Subject: MHI's Responses to US-APWR DCD RAI No.391-2974 Revision 1

Reference: 1) "Request for Additional Information No. 391-2974 Revision 1, SRP Section: 06.03
– Emergency Core Cooling System" dated June 15, 2009

RESPONSE TO REQUEST FOR ADDITIONAL INFORMATION

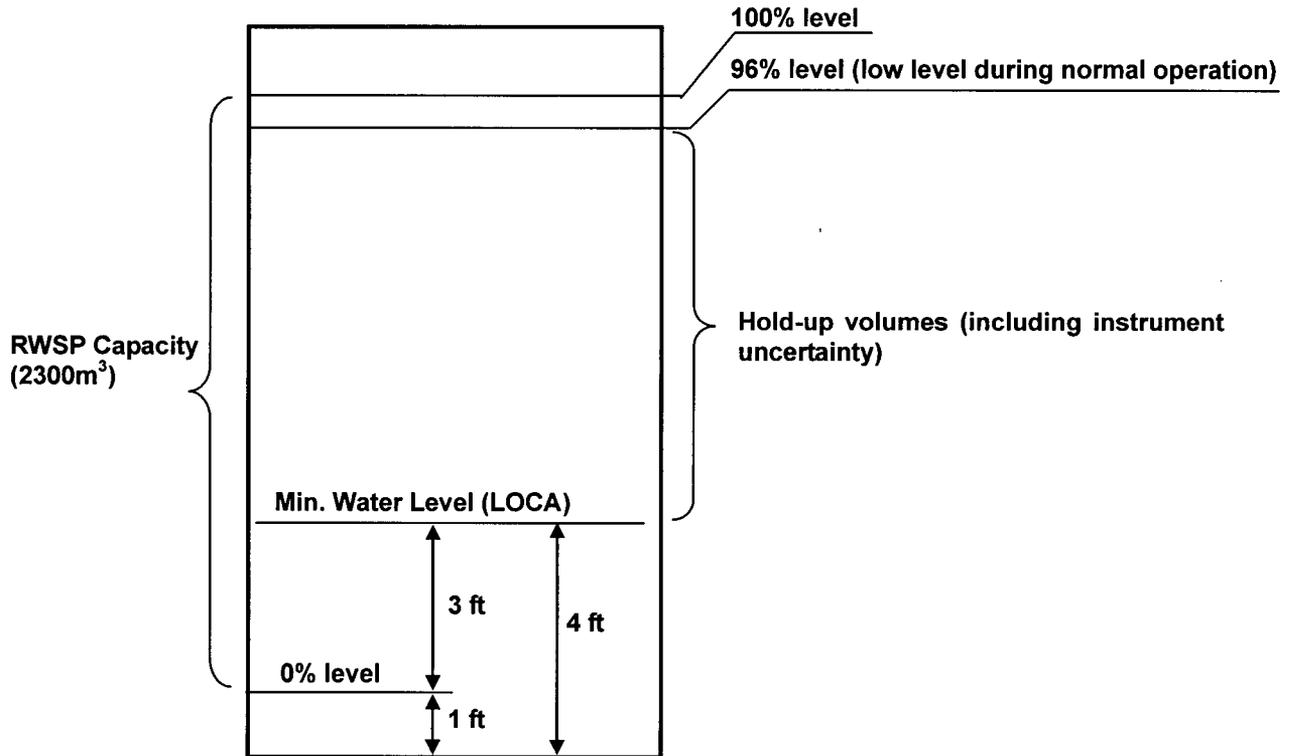
It is stated in Section 6.3.2.2.3 that "The RWSP capacity includes an allowance for instrument uncertainty and the amount of holdup volume loss within the containment." Where are the instrument uncertainty and holdup volume loss assessments documented? Provide the references.

The assessment of holdup volumes associated with RWSP water volume calculation is provided in the following references:

- The DCD subsection 6.2.2.2.5 discusses the capacity of the RWSP and hold up volumes as follows:

The RWSP is located on the lowest floor inside the containment, with a minimum 81,230 ft³ capability available, it is designed with sufficient capacity to meet long-term post-LOCA coolant needs, including holdup volume losses. Potential holdup areas within the containment are depicted in Figure 6.2.1-9.
